Drawing Title: ELECTRICAL 3RD, 4TH AND 10TH FLOOR POWER ONE LINE SCHEMATIC AND RISER DIAGRAM

Project Title: RENOVATE FOR CLINICAL IMPROVEMENTS

Project Number: 583C16254
Building Number: 1
Drawing Number: EP-600
3FY12

1 MI600 SYSTEM CONTROL DIAGRAM
NTS

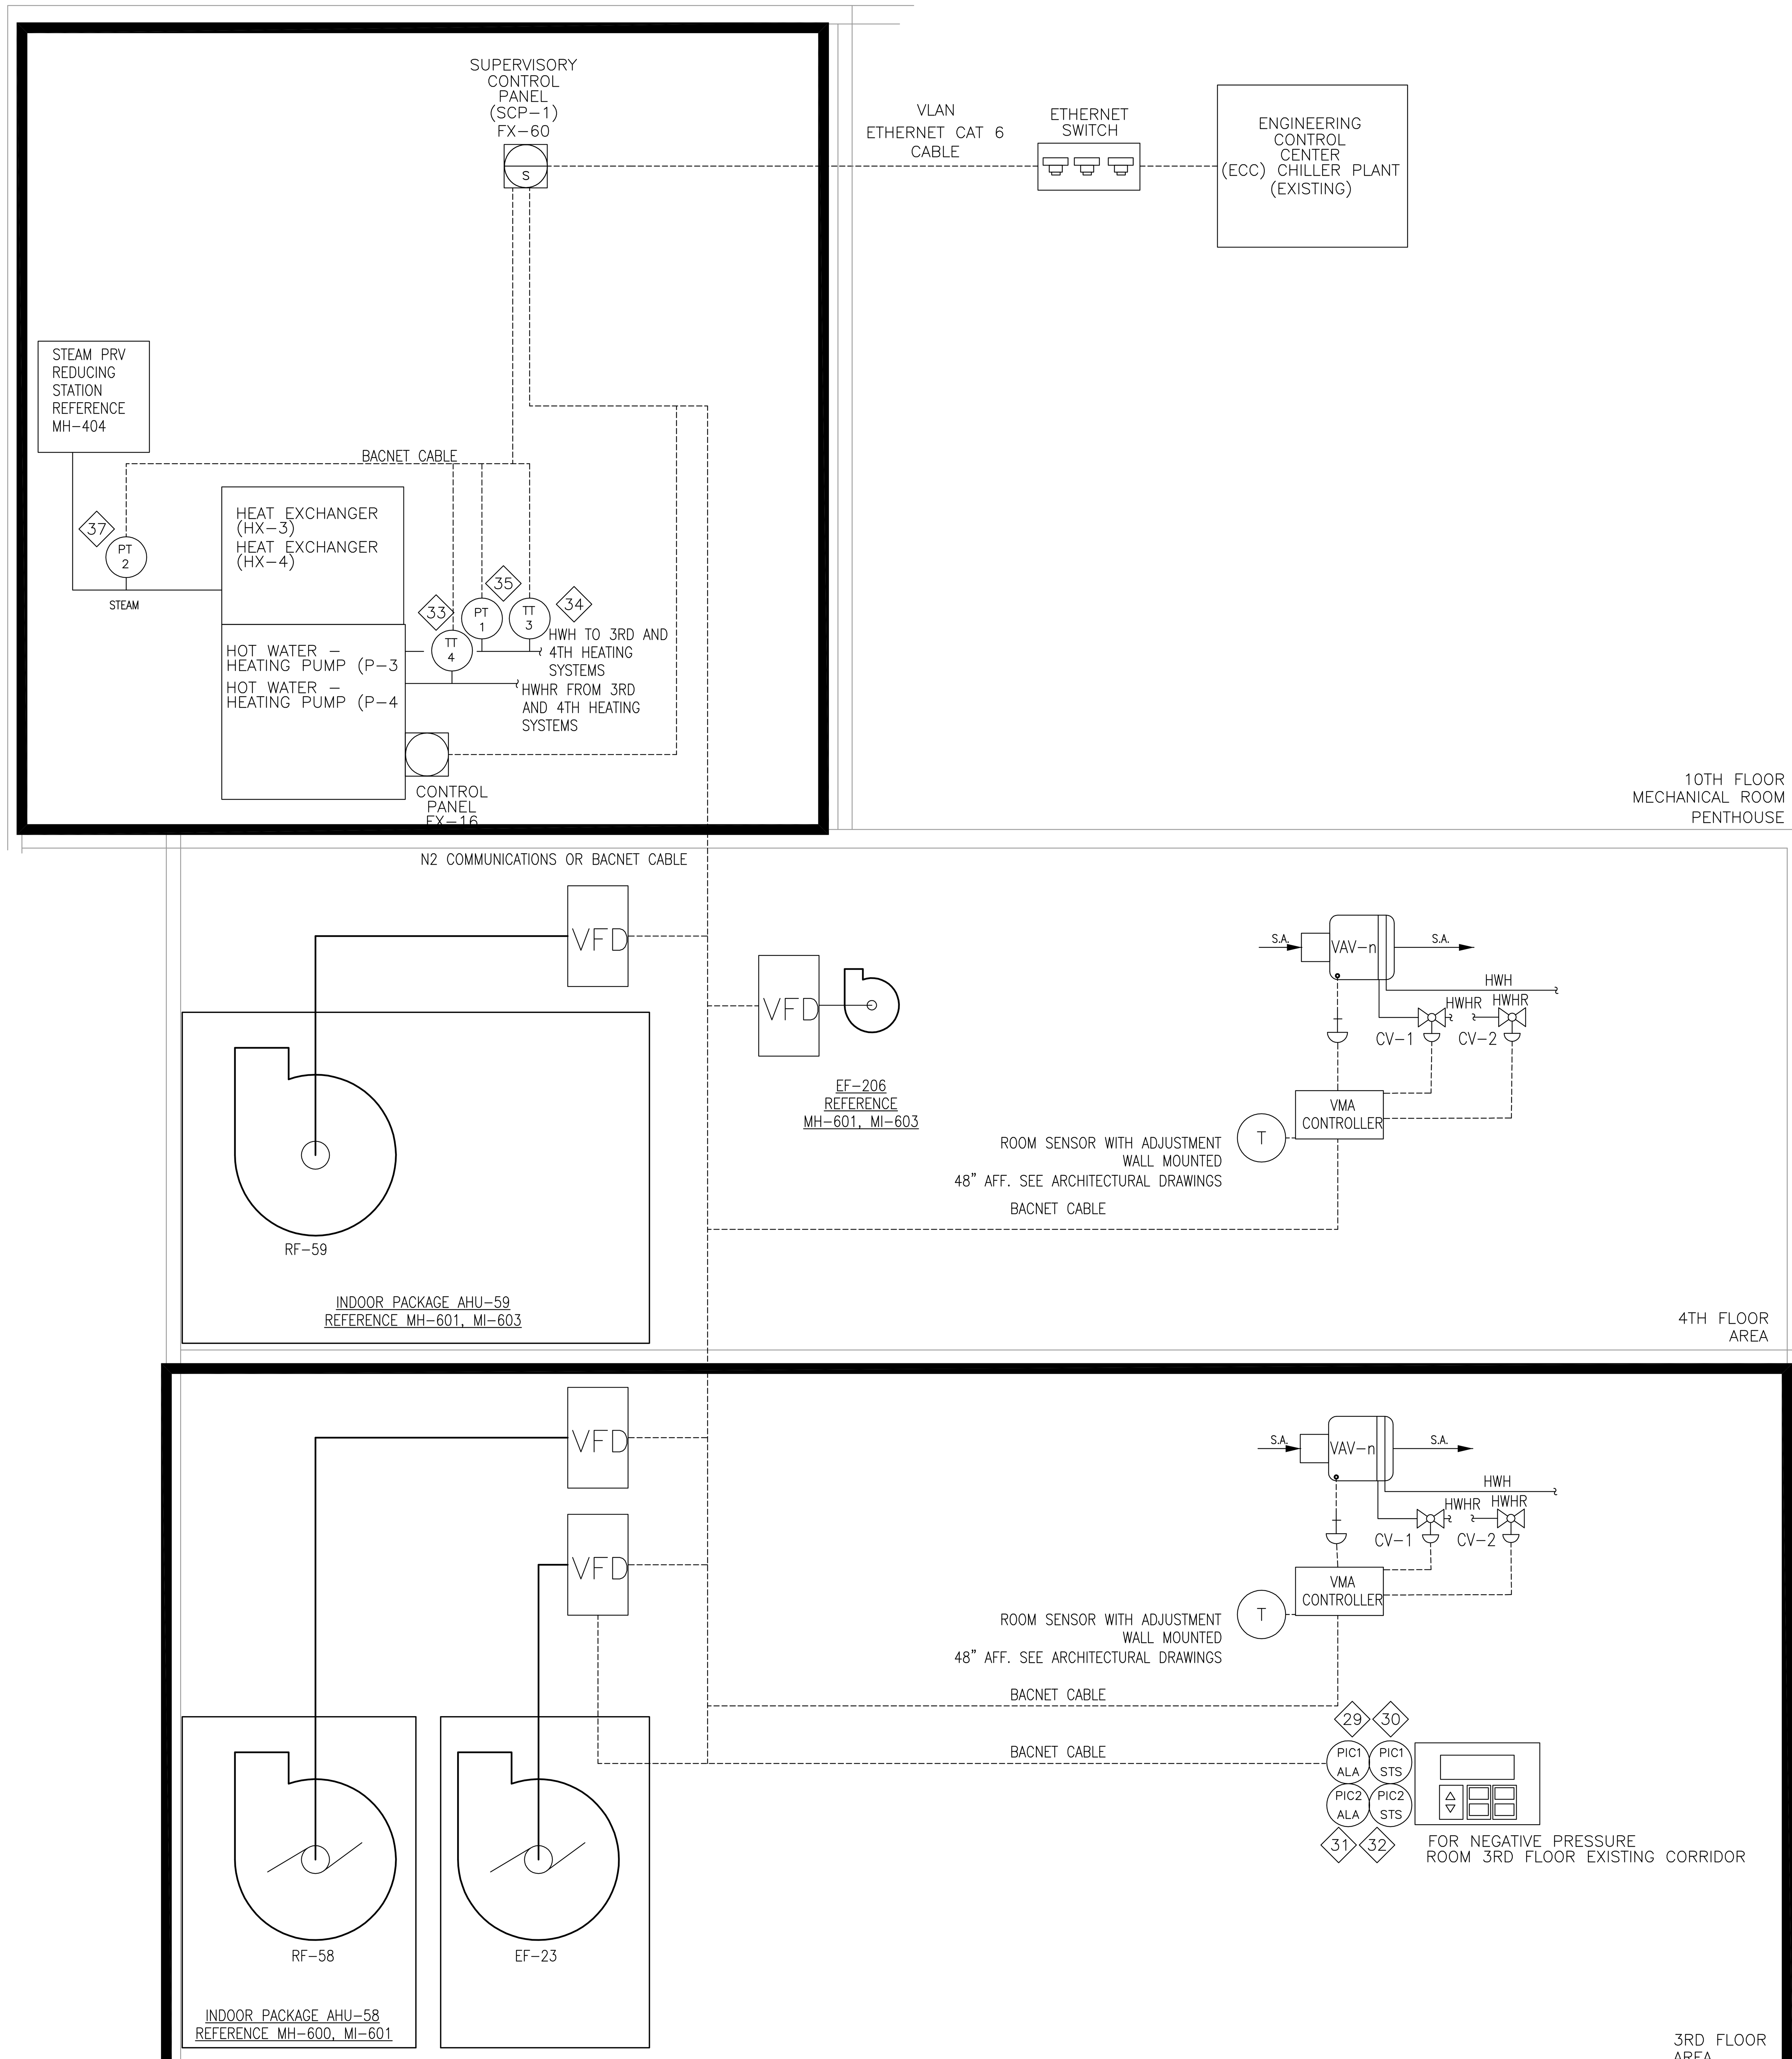
Revisions	Date
65% SUBMITTAL SET	01.07.2012
95% SUBMITTAL SET	03.07.2012
BID DOCUMENTS SUBMITTAL SET	05.14.2012
REVISION - ADDED MAKE UP FILL STATUS CONTROL POINT	8-28-2012

1 MI601 AIR HANDLING UNIT AHU-58 AND EXHAUST FAN EF-23
NTS CONTROL DIAGRAM

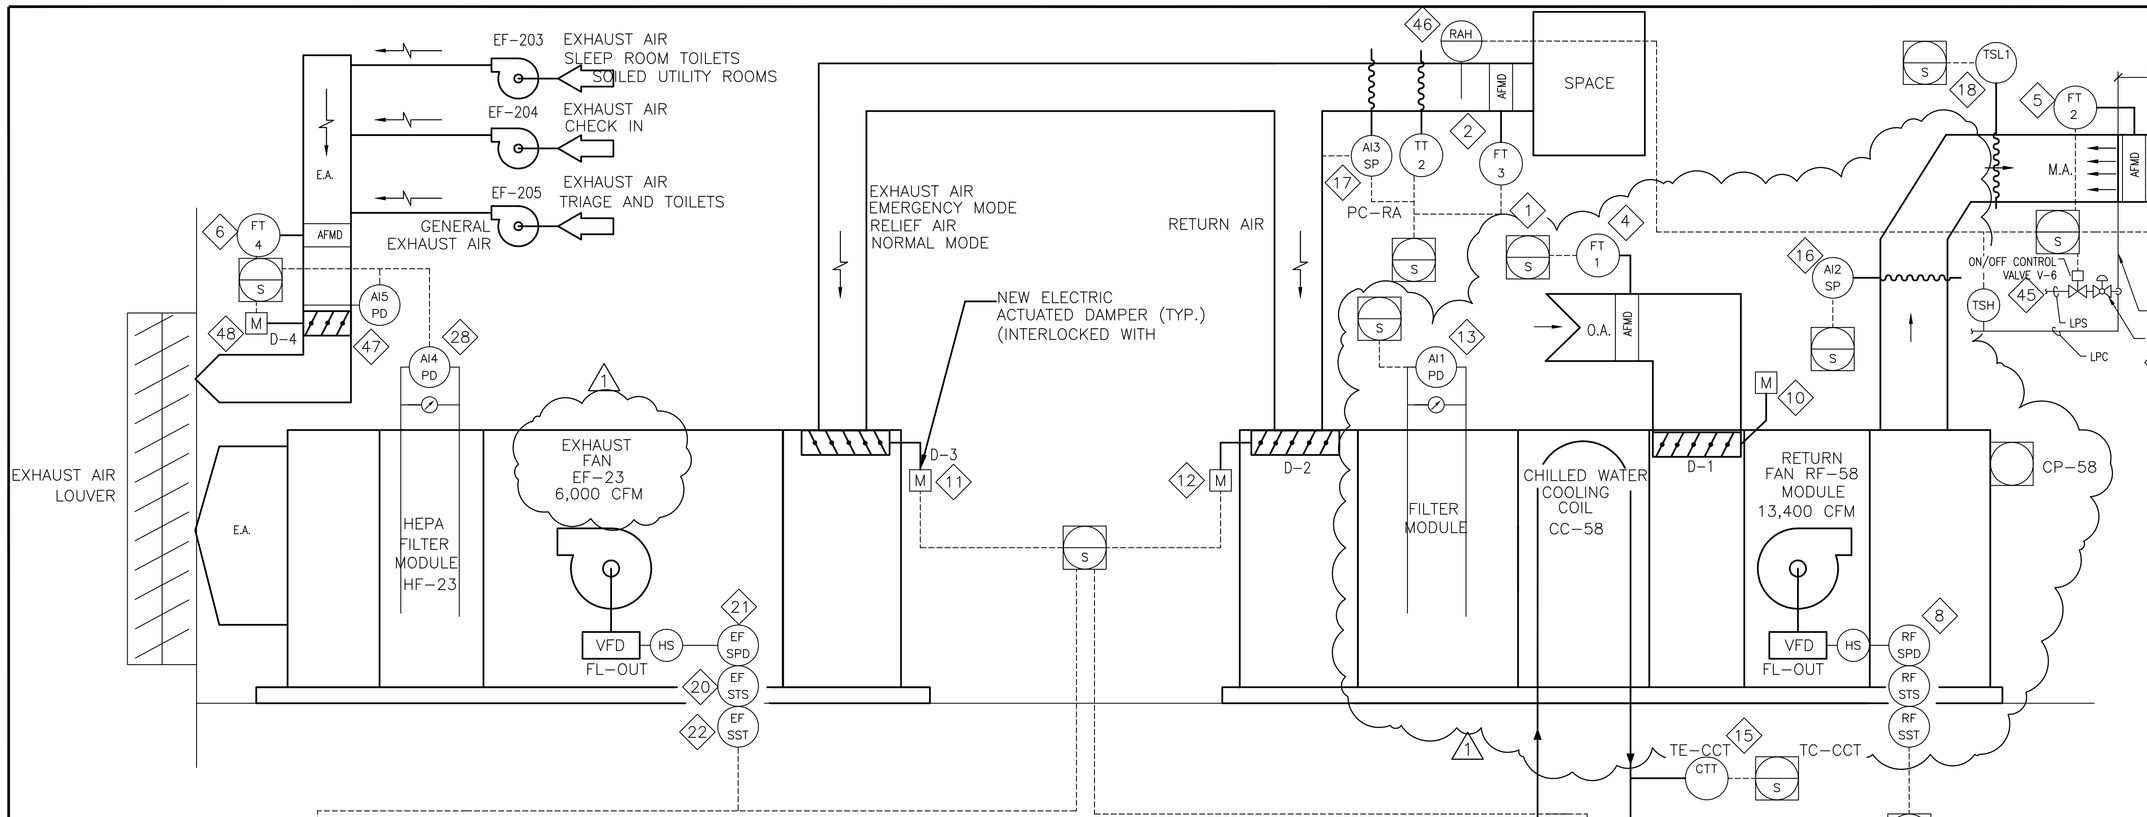
65% SUBMITTAL SET	01.07.2012	
95% SUBMITTAL SET	03.07.2012	
BID DOCUMENTS SUBMITTAL SET	05.14.2012	
REVISION - CORRECTED AHU-58 ARRANGEMENT	8-28-2012	
REVISION - CORRECTED EF-23 PERFORMANCE	8-28-2012	
REVISION - ADDED CONTROL POINT FOR MAKEUP FILL TANK	8-28-2012	
Revisions:	Date

1 MI602 SYSTEM CONTROL DIAGRAM
NTS

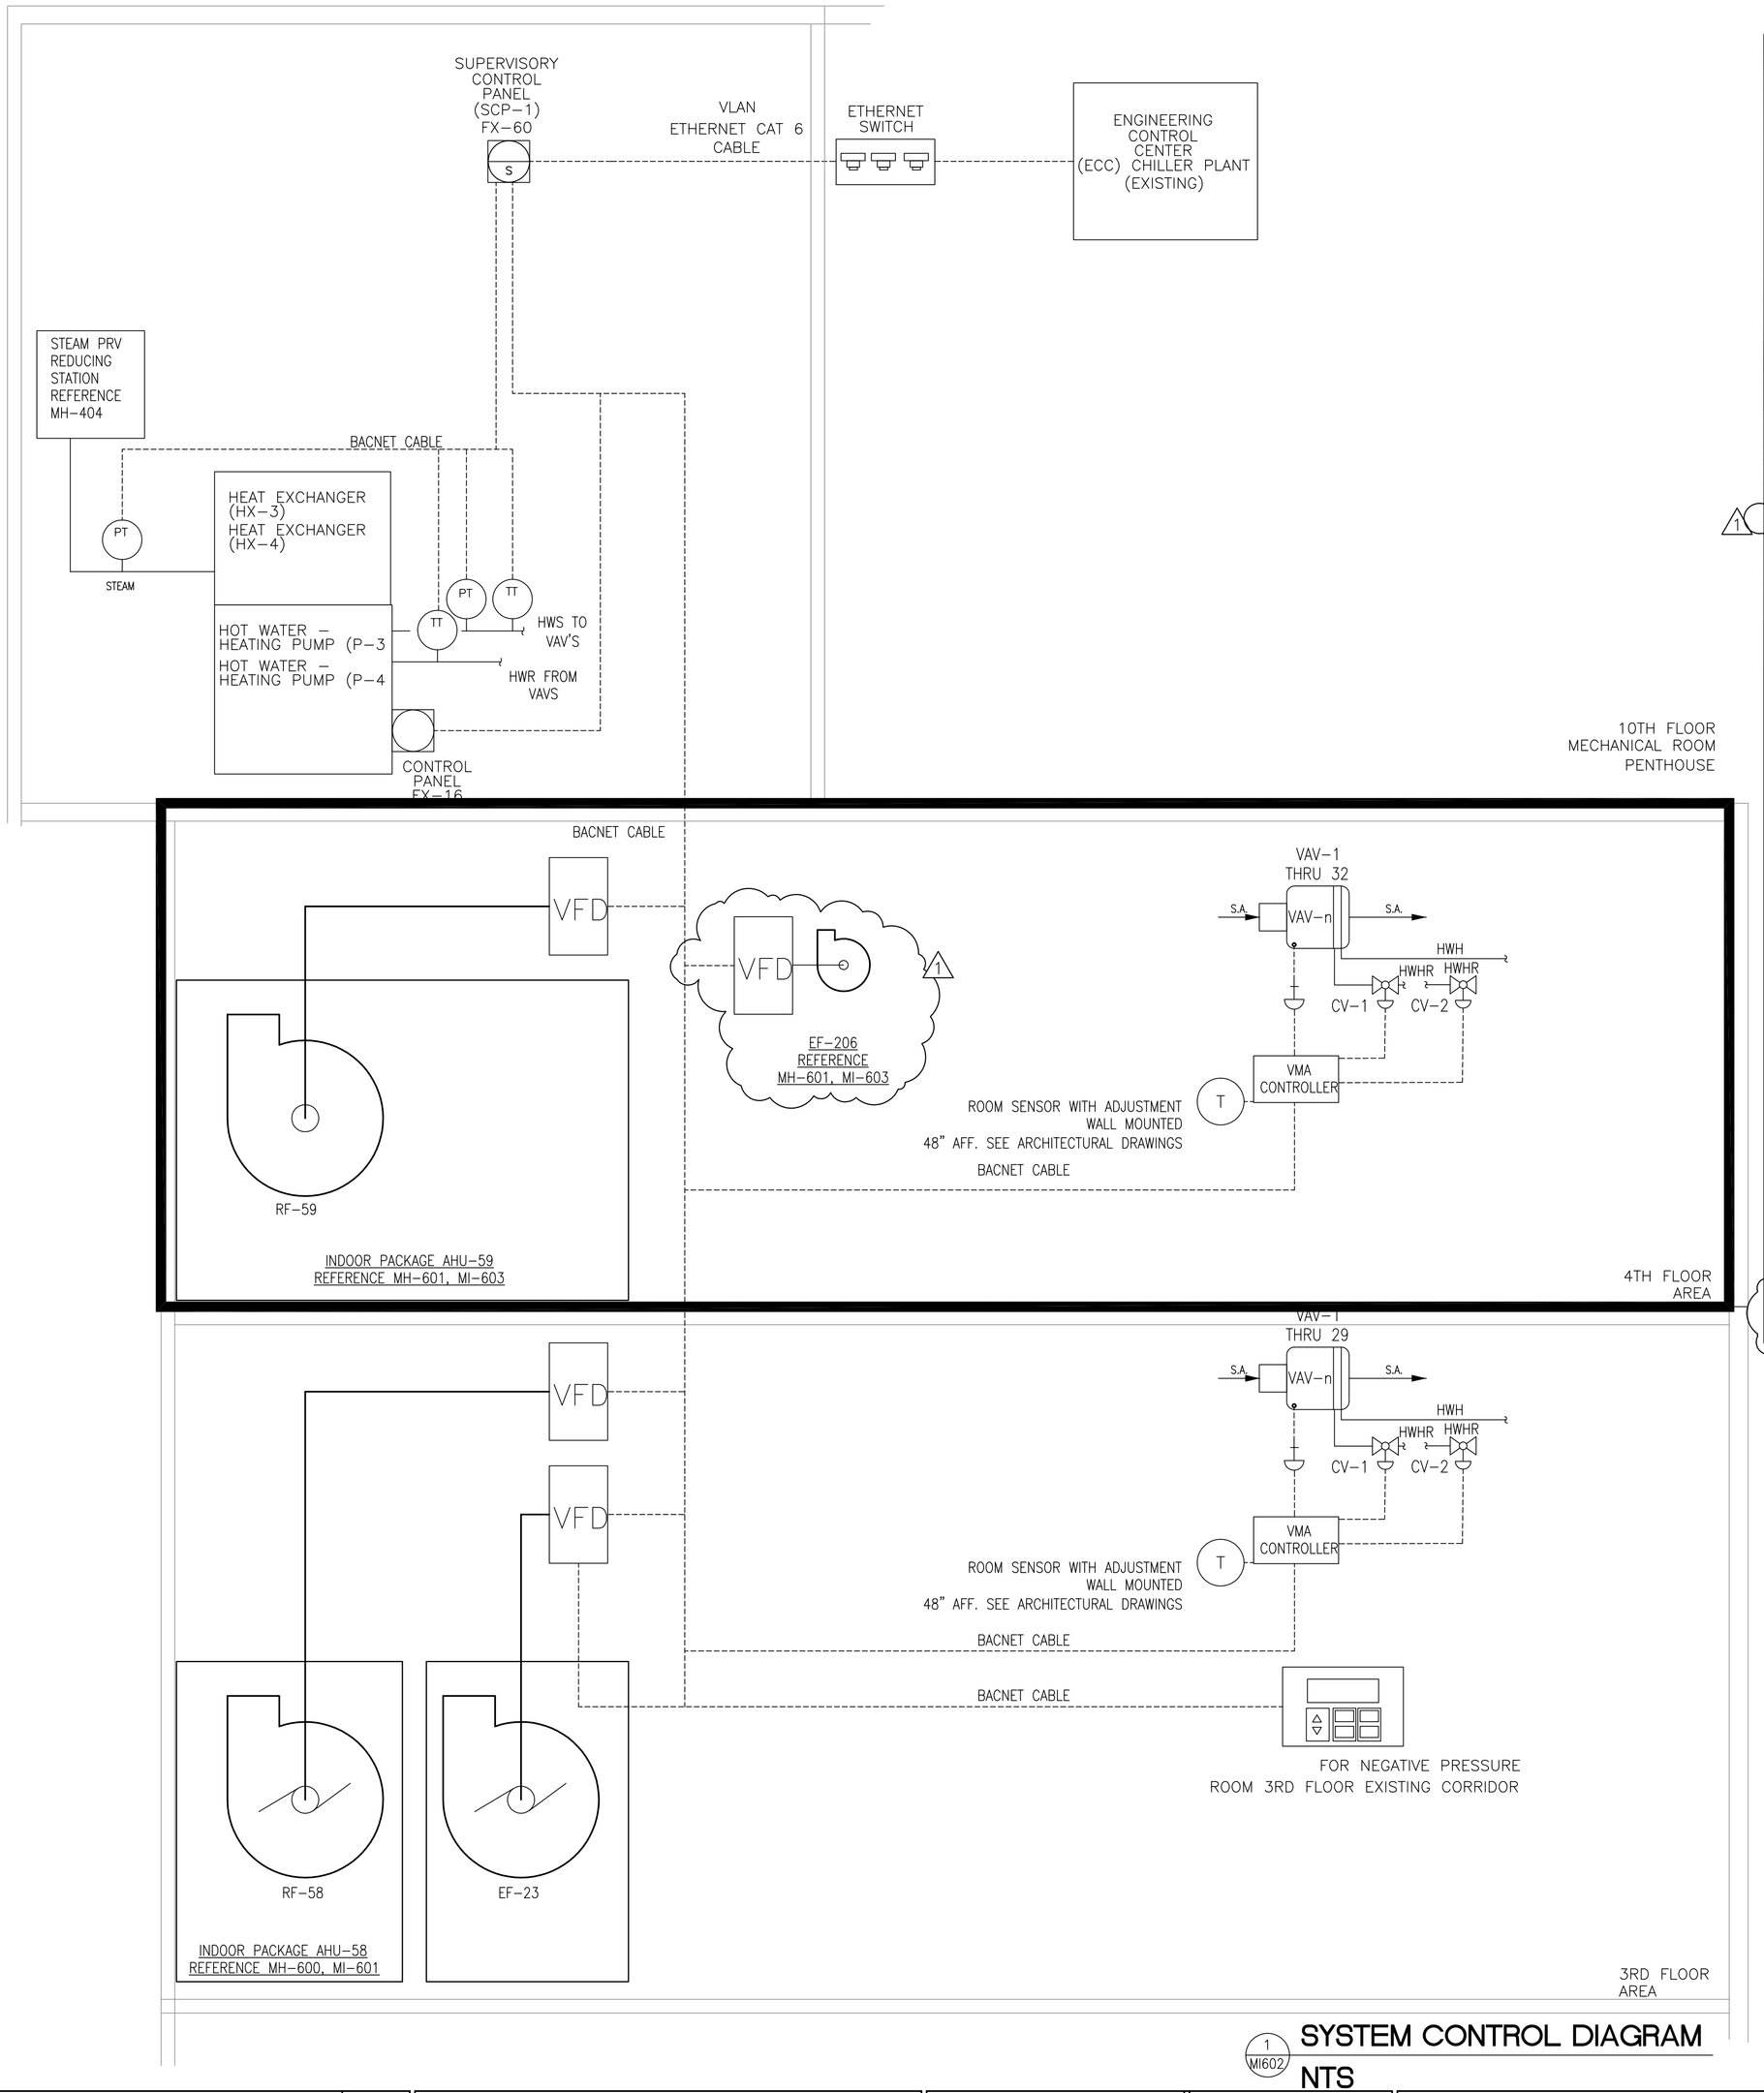
Revisions:	Date
65% SUBMITTAL SET	01.07.2012
95% SUBMITTAL SET	03.07.2012
BID DOCUMENTS SUBMITTAL SET	05.14.2012
REVISION - ADDED EF-206 AND VFD-6 CONTROL POINTS	8-28-2012
REVISION - MODIFIED RELIEF DAMPER DESCRIPTION	8-28-2012

1 MI603 AIR HANDLING UNIT AHU-59
NTS CONTROL DIAGRAM

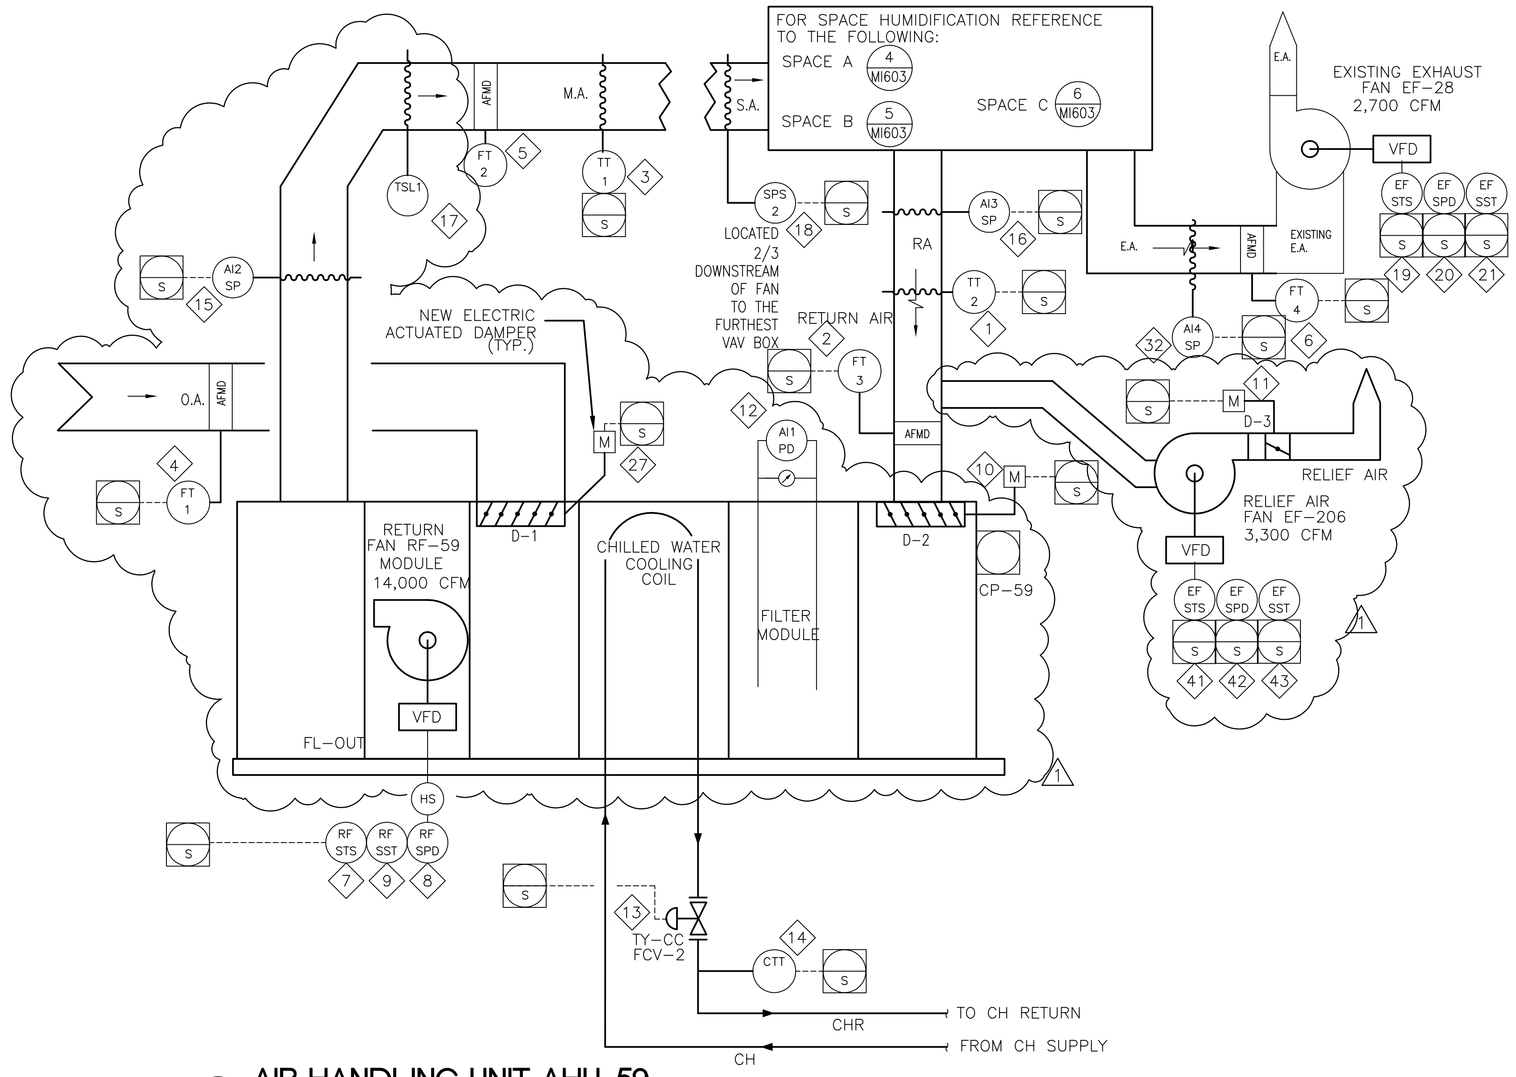
65% SUBMITTAL SET	01.07.2012
95% SUBMITTAL SET	03.07.2012
BID DOCUMENTS SUBMITTAL SET	05.14.2012
REVISION - CORRECTED AHU-59 ARRANGEMENT	8-28-2012
REVISION - ADDED EF-206 AND VFD-6 FOR EF-206	8-28-2012
REVISION - MODIFIED AHU-59 SEQUENCE OF OPERATION	8-28-2012
Revisions:	Date
